Board of Adjustment
Meeting Agenda
City of Creve Coeur Government Center
300 North New Ballas Rd

1. Variance Request for the Property at 108 North Mosley Road to Construct an Accessory Structure at 13 Feet, 10 Inches in Height Rather Than the Required 12 Foot Height Allowance for All Accessory Structures

APPLICATION TO THE BOARD OF ADJUSTMENT VARIANCE REQUEST FOR THE PROPERTY AT 108 NORTH MOSLEY ROAD TO CONSTRUCT AN ACCESSORY STRUCTURE AT 13 FEET, 10 INCHES IN HEIGHT RATHER THAN THE REQUIRED 12 FOOT HEIGHT ALLOWANCE FOR ALL ACCESSORY STRUCTURES

Figure 1: Close-up of the proposed site plan. The red line indicates the proposed accessory structure.

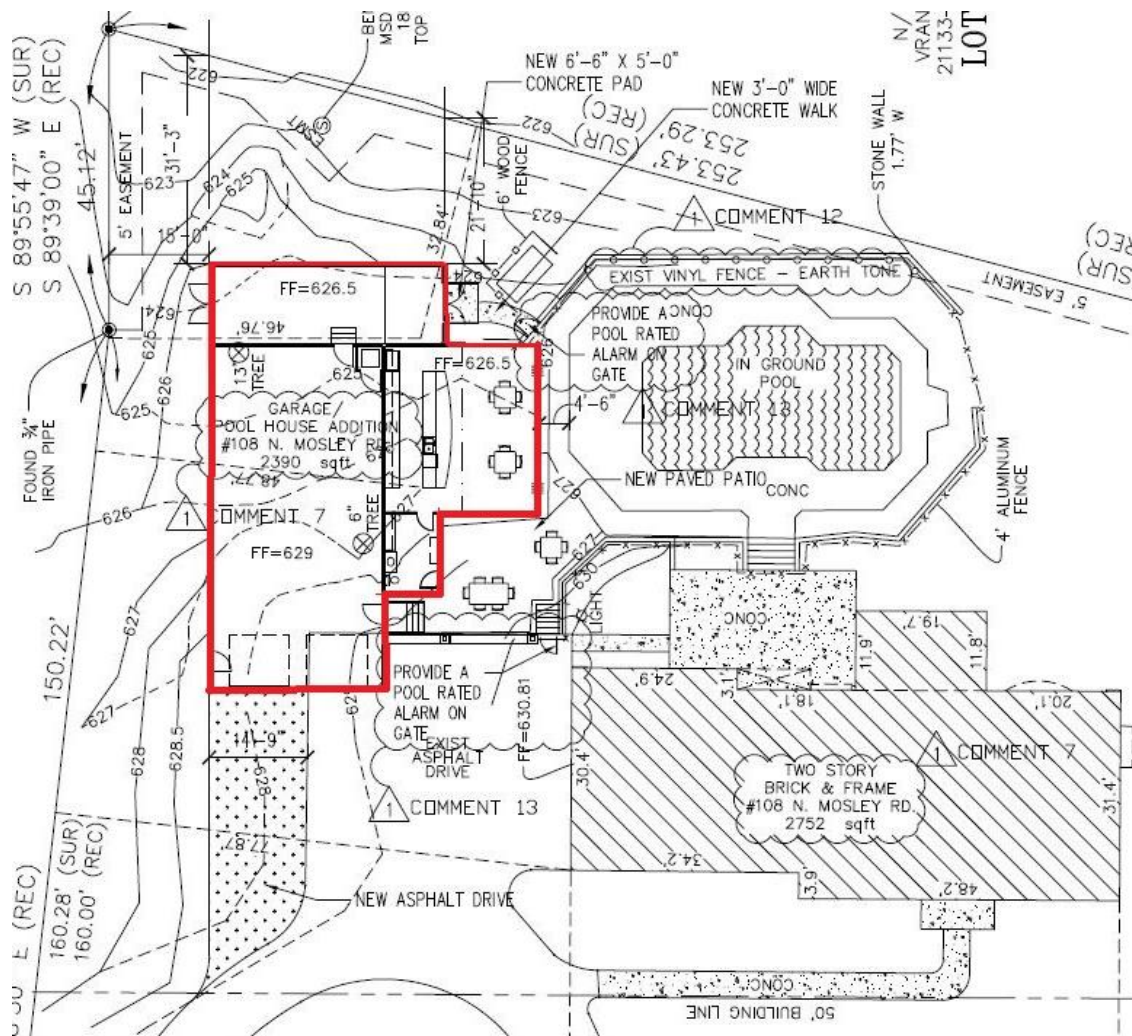
The Applicants are seeking a variance from the 12-foot height maximum for all accessory structures to allow a new free-standing pool house with attached garage and storage room at a height of 13 feet, 10 inches, with an area of 2,390 square feet. Per Section 405.120, Building Height is defined as, *“The vertical distance from grade to the highest point of the coping of a flat roof or to the deck line of a mansard roof or to the mean height level between eaves and ridge of a gable, hip or gambrel roof. In the case of new construction and building additions, building height shall be measured from the existing grade prior to the commencement of any construction.* Following this section, the height of the accessory structure’s roof measures at 13 feet, 10 inches.

Section 405.460 (C)(5) of the Accessory Uses and Structures states, “*Accessory structures in any residential district shall not exceed twelve (12) feet in height with the exception of walls, fence or hedges located within the required side, rear or front yard setback which shall not exceed six (6) feet in height.*” The topography of the lot includes a slope towards the northeast corner which effects the existing grade at the location of the proposed accessory structure. Due to the topography of the lot and the chosen height of the accessory structure, the height and placement of the accessory structure does not comply with the Zoning Code.

Figure 2: Proposed west elevation facing North Mosley Road

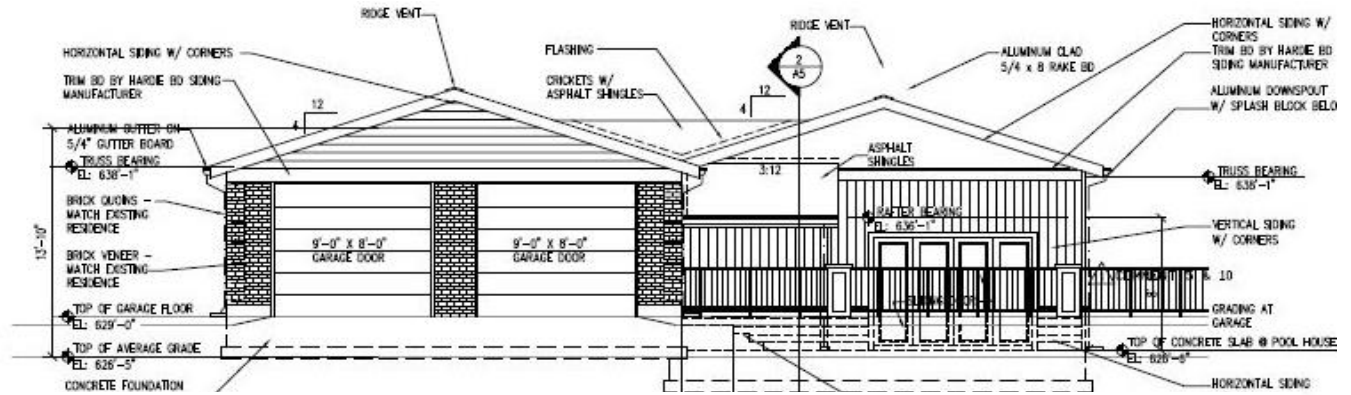
The applicants have not presented evidence that proves strict application of the 12-foot height maximum for accessory structures would cause severe practical difficulty or extreme hardship for the property owner. The applicants have been provided suggestions for alternative design plans for the accessory structure that would comply with the provisions of the Zoning Ordinance. The provisions of the Zoning Ordinance and the conditions of the lot do not make it impossible to construct an accessory structure of similar size and use on the lot or in the same location as proposed. It should be noted that the Zoning Ordinance does not impose a specific size limitation for accessory structures and the applicant's plans show the site coverage at 24.99%, just below the maximum allowance of 25%. The question before the Board, under this criterion, is whether or not the inability to fully exercise the design of the proposed accessory structure represents an extreme hardship. The Applicants are maintaining the existing slope

causes their accessory structure to fall outside of the height limitations and that if the site were level, calculated from the west end of the building, their plans would not be out of compliance or require a variance.

Figure 5: Contours of 108 N. Mosley and Surrounding Lots

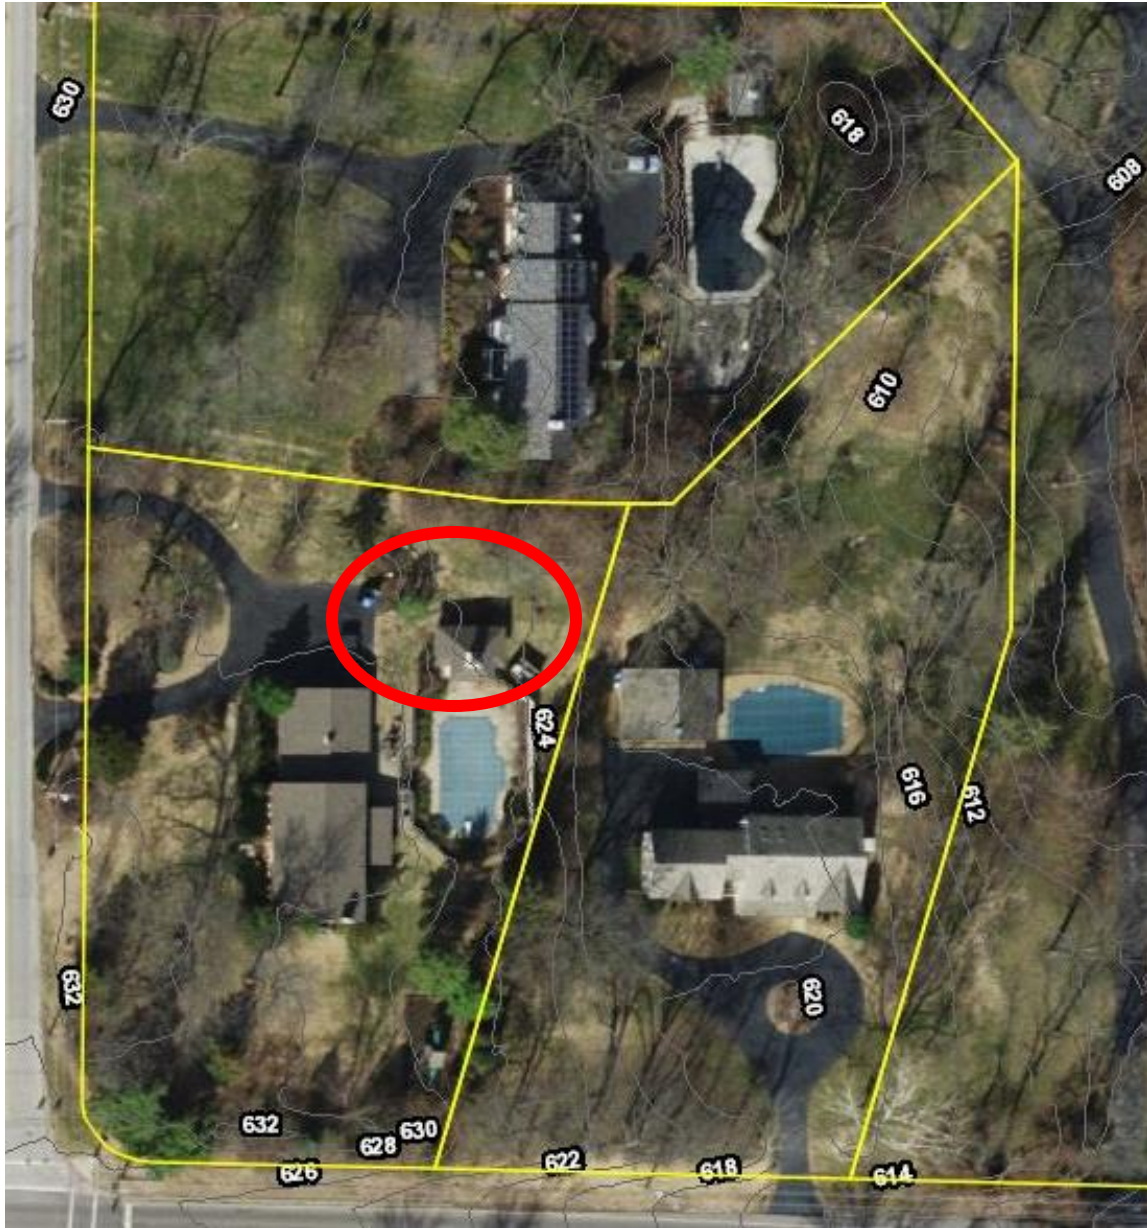
The subject property is a pre-existing, non-conforming lot. The square footage of the lot is slightly below the minimum lot area of 1 acre (43,560 square feet) at 41,216 square feet but these conditions are also found in many of the surrounding lots in the same zoning district. The lot has a slope towards the northeast corner which effects the existing grade prior to construction. When reviewing the contours of the surrounding lots, several lots have an equal or greater slope present, making this grade change not unique to the property in question and not out of the ordinary for lots in the same zoning district (see Figure.5).

Although the size of the lot is slightly under the minimum lot area of 1 acre and the topography of the lot creates a downward slope towards the north east corner of the lot, affecting the average grade calculation, these conditions do not constitute exceptional conditions or circumstances that create a hardship to the property in a manner that is dissimilar to that of other similarly situated
